IMPROVEMENT PERMIT for a RESIDENTIAL ON-SITE WASTEWATER TREATMENT & DISPOSAL SYSTEM

Permit #: **30001381** GWS File #: **6764B** Tax Parcel #: **023-201-02**

GWS Septic System Design Review

RE: Request for an Improvement Permit for Lot 26 off of Sample Road at The Retreat at Latta Plantation
MCHD File #6764B

Scale: 1 inch equals 50 feet	S&ME	Faison - Sample Road LLC	FIGURE
Drawn by: JBP		Lot 26	1
Reviewed by: TCJ		Mecklenburg County, NC	
Date: June, 2007	ENVIRONMENTAL SERVICES · ENGINEERING · TESTING	S&ME Project #1588-05-091

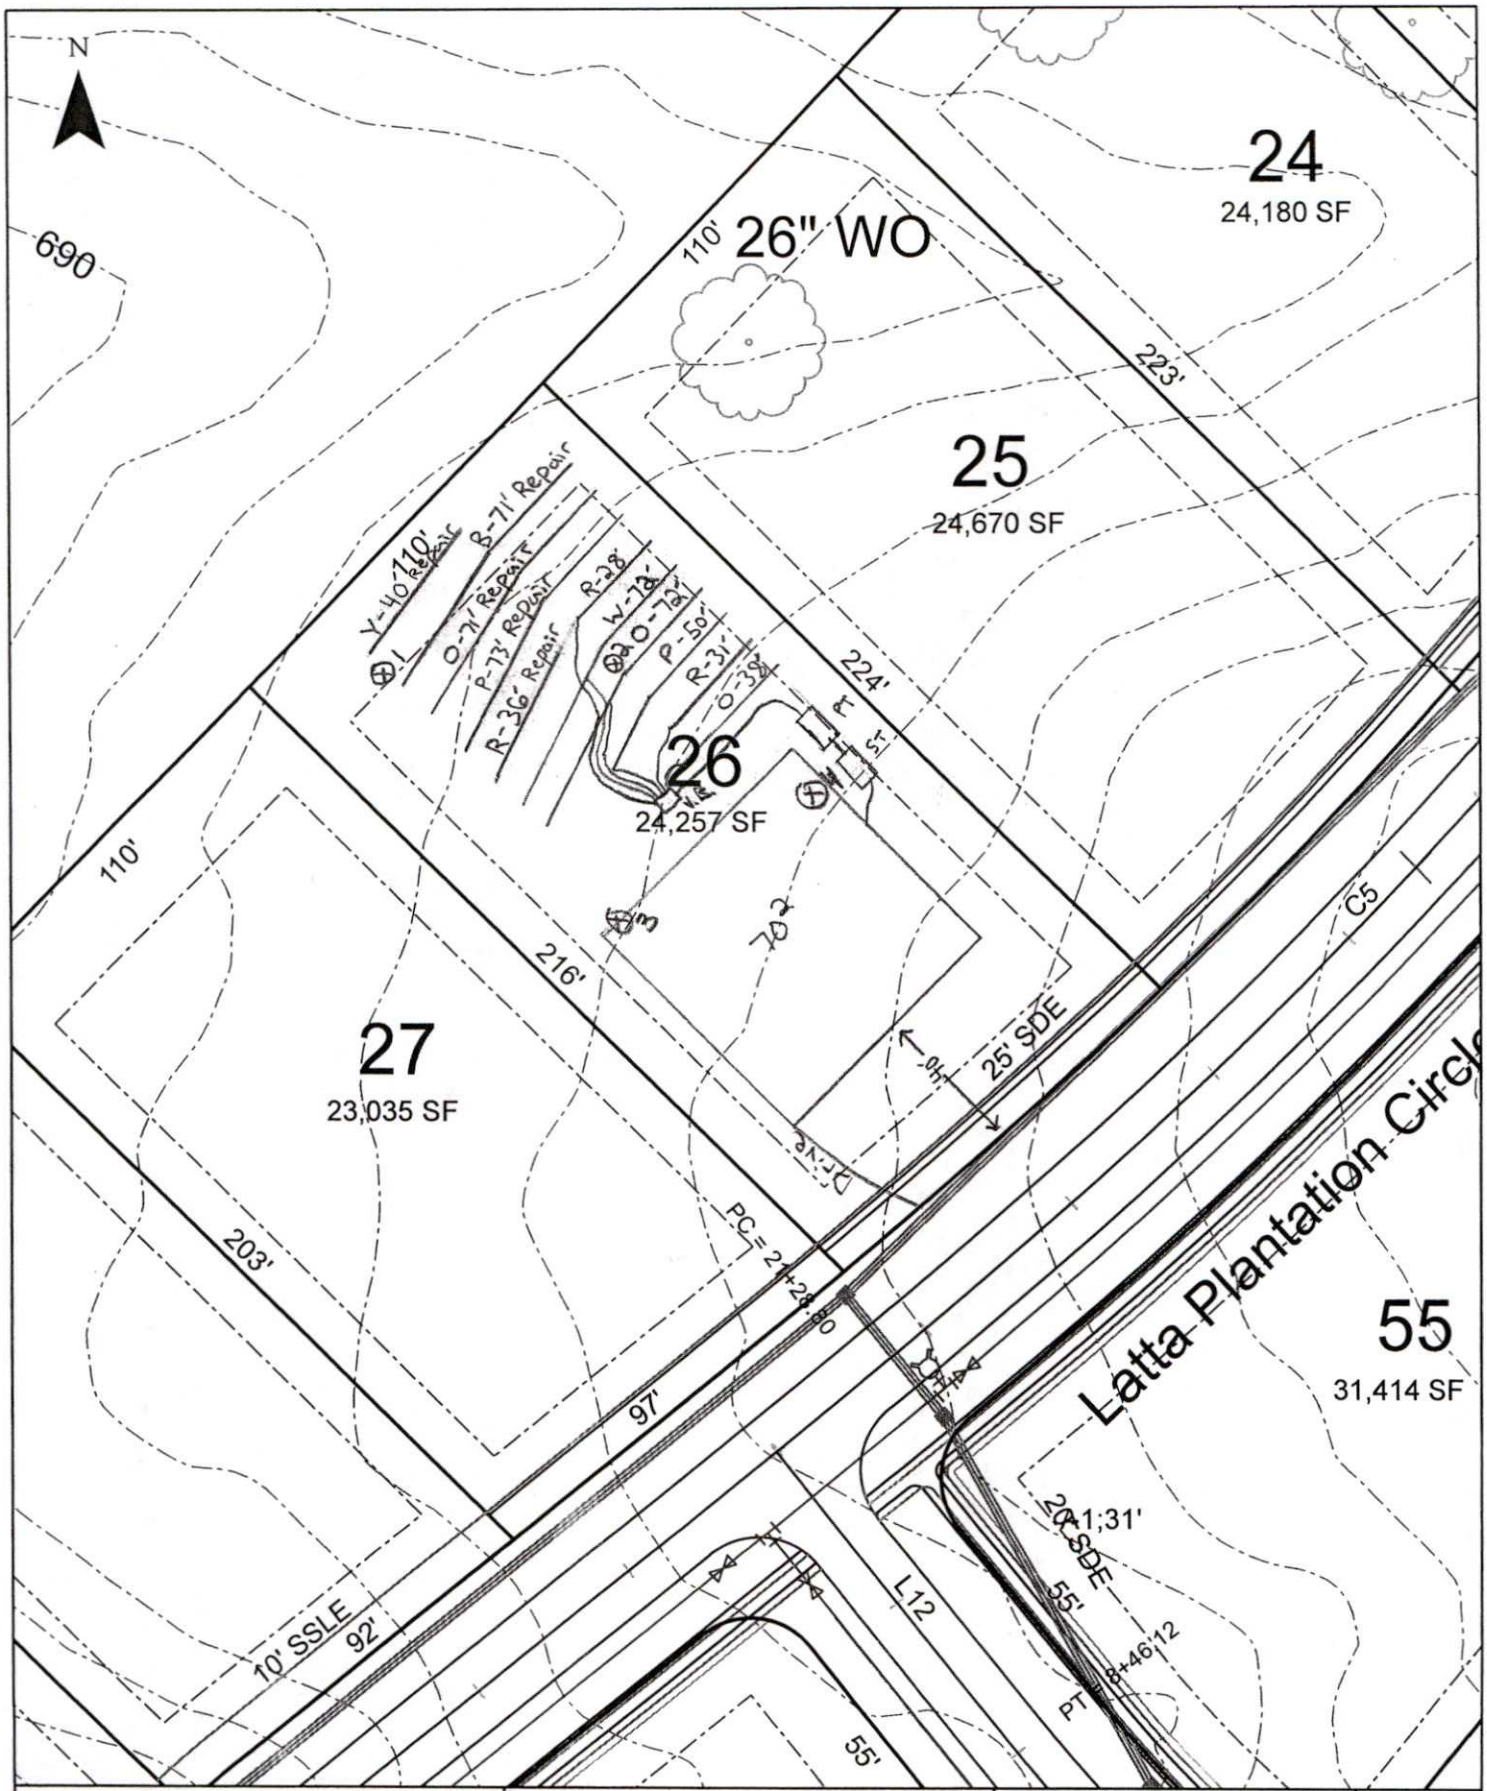
The proposed system is a TYPE IV and will require a contract with a Certified Operator to supply maintenance services for the septic system. Please review the attached system sketch and design specifications for the Improvement Permit. If necessary, the MCHD may add comments to the site plan or specifications. Please call if you have any questions or comments.

Notes: Before placement of cap block, one panel on each line, near the center of the field should be observed filling to make certain that it does not overflow the top chamber into the air chambers. If overflow occurs, reduce floats by 25 gallons and reset until no overflow is observed.

1. Install system using 3 ft. wide trenches.								
2. Install drainlines on 9 ft. centers, level, and on contour.								
3. System design requires effluent pump for distribution.

4. 100% Repair area is required.

Approved	Disapproved
GWS File #: 6764B		
Design Review: TCT 6-18-07	☒	☐
Field Review: 6/19/07	☒	☐
